# Access Compliance Report

## Public Rights-of-Way

Intersection ID: 28305	Main Street: COMMUNITY HOUSE RD	Cross Street: TAMARRON DR	Location: SE
ADA ID: 79748B17939C	Ramp Type: Perp	Initial Pass/Fail: Fail	Overall Compliance: No
Codes/Mitigation Info/Possible Solution			Severity Score: 10
			Field Measurements/Component Compliance

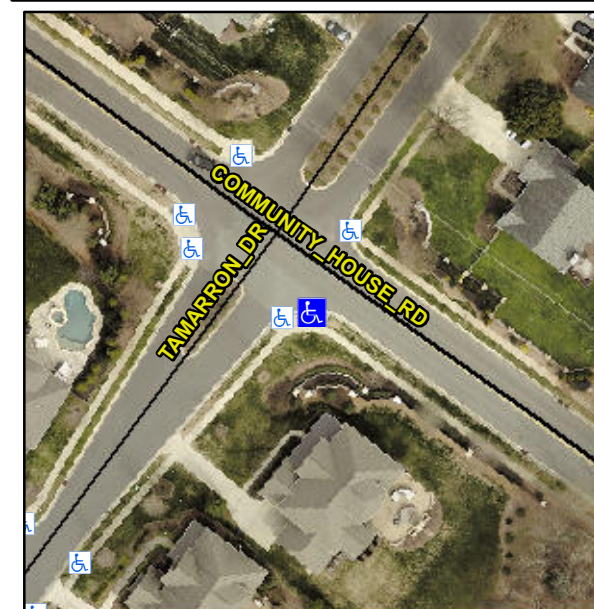
**Not Found, R304.5.1, R304.5.3**

Compliance	Description	Data	Compliance	Description	Data
N/A	Ramp Length (in)	71.0	Yes	Ramp Slope (%)	6.3
No	Ramp Width (in)	47.0	No	Ramp XSlope (%)	4.0
N/A	Flare Type LT	N/A	N/A	Flare Type RT	N/A
N/A	Flare Slope LT (%)	N/A	N/A	Flare Slope RT (%)	N/A
N/A	Flare Traversable LT?	N/A	N/A	Flare Traversable RT?	N/A
N/A	Landing Length (in)	N/A	N/A	DWS Provided?	N/A
N/A	Landing Width (in)	N/A	N/A	DWS Contrast?	N/A
N/A	Landing Slope (%)	N/A	N/A	DWS Length (in)	N/A
N/A	Landing X Slope (%)	N/A	N/A	DWS Full Width?	N/A
N/A	Landing Curb? (Y/N)	N/A	N/A	DWS Offset (in)	N/A
N/A	Shared Landing?	N/A			
N/A	Gutter Ponding?	N/A	N/A	Gutter Slope (%)	N/A
N/A	Gutter Lip Ht (in)	N/A	N/A	Gutter X Slope (%)	N/A
N/A	Painted X Walk1?	No	N/A	Painted X Walk2?	N/A
	X Walk 1 Direction	To NE		X Walk 2 Direction	N/A
N/A	X Walk 1 Width (in)	N/A	N/A	X Walk 2 Width (in)	N/A
	X Walk 1 Slope (%)	5.8		X Walk 2 Slope (%)	N/A
	X Walk 1 X Slope (%)	0.7		X Walk 2 X Slope (%)	N/A

**Remove & Replace Entire Ramp.**
